Planning and Zoning Board

CASE NUMBER: Preliminary Plat for "BB Living at Eastmark"
LOCATION/ADDRESS: The 9800 through 10000 blocks of east Ray Road (north side)
GENERAL VICINITY: Located east of Ellsworth Road on the north side of Ray Road
REQUEST: Preliminary Plat
PURPOSE: This request will allow for the subdivision of approximately 11.27 acres within the Eastmark Community.
COUNCIL DISTRICT: District 6
OWNERS: DMB Mesa Proving Grounds, LLC
APPLICANT: Branden Lombardi, BB Living Residential
STAFF PLANNER: Tom Ellsworth

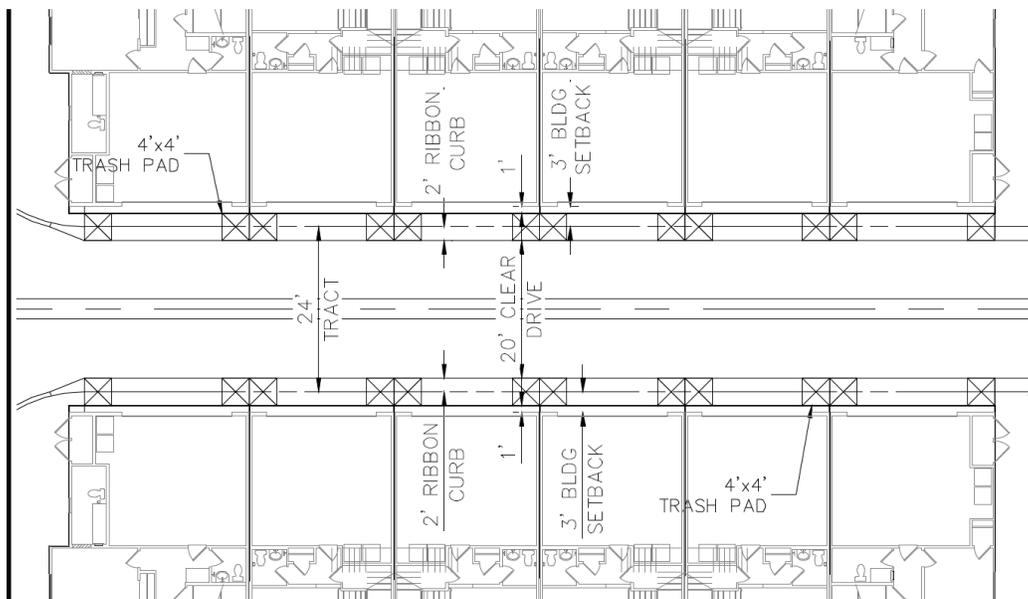
The applicant has worked with staff to alleviate this concern by providing parking throughout the subdivision at a ratio of 2.48 spaces per unit (two spaces in each garage plus .48 guest spaces per unit). Staff goal in cluster projects has been to have at least 2.5 parking spaces per unit and to have the guest spaces within 150' of the entry to the cluster. This puts the furthest parking space within 200 feet of the furthest unit. Staff has some concerns with the number and location of the proposed guest parking, particularly on the western portion of the development.

For example, for lot 1 – 8 and 124 – 132 (a total of 21 homes), there are only 4 off-street parking spaces (just north of lot 115), and seven on-street parking spaces in Reliance Way for guests. In some of the other cluster and small lot developments we have experienced problems with people parking along the street where they are not supposed to and causing conflicts with solid waste pick up. We want to avoid that situation in this development.

The applicant has agreed to not allow parking on the main private spine road or the service roads. A note will be required to be placed on the final plat stipulating that parking is prohibited along Hawk Avenue and the private service drives except in the designated parking locations (see condition #5a). The plat also includes pad locations for solid waste pick up. Each of these pads will be marked by a brass cap designating which pads belong to which unit. Parking will not be allowed at these pad locations (see condition #5b). While staff would prefer to see the plat modified to increase the number of parking spaces and provide them closer to the units, the applicant and the Eastmark Development have assured us they will police the parking and ensure it does not happen along Hawk Avenue where it will be prohibited.
